Access Compliance Report Public Rights-of-Way (Curb Ramps)

Main Street: CLARIN_ST Cross Street: NARROW_CANYON_RD Location: W

ADA ID: RPRK211028140341 Ramp Type: Type 1 - Perpendicular Initial Pass/Fail: Pass Overall Compliance: No Severity Score: 16

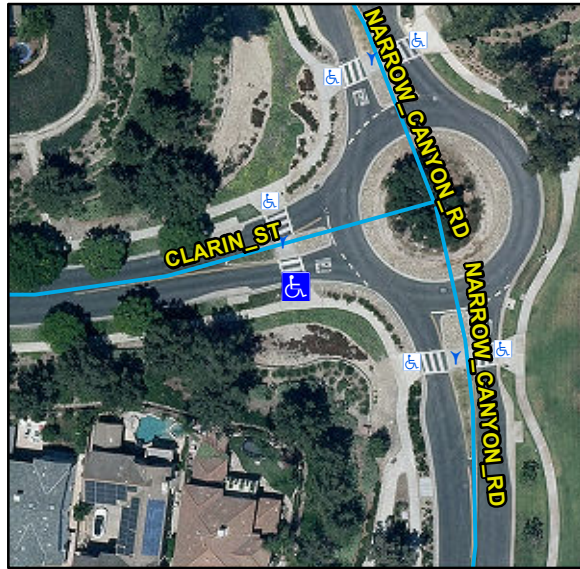
Remove & Replace Entire Ramp. Remove & Replace Gutter.

R204.3, R304.2.2-Perp, R304.3.2-Para, R304.5.3, R305, R304.5.4, STD 1115
